Product Change Notice

Issue Date: 13-December-2021

0.56" Dual Digit Scrambler poles modification for Leadframe Seven Segment Display

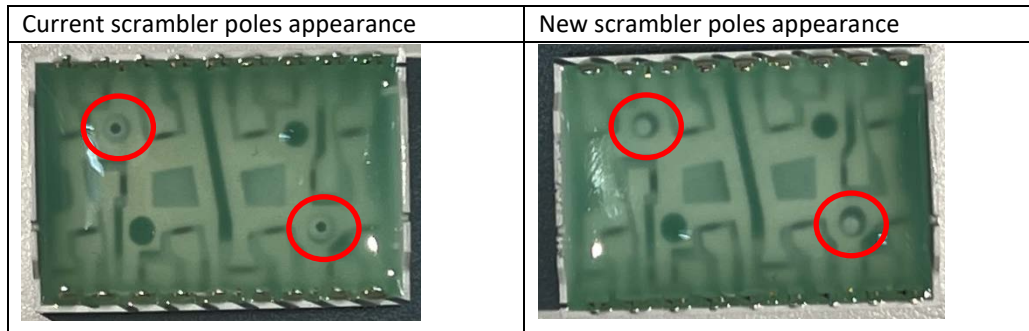
Description and Extent of Change:

The new scrambler will replace current scrambler for part numbers above.

Improve the strength of scrambler poles.

There is no change in fit and function of the product as per datasheet. However, there is a minor scrambler poles appearance change as illustrated below.
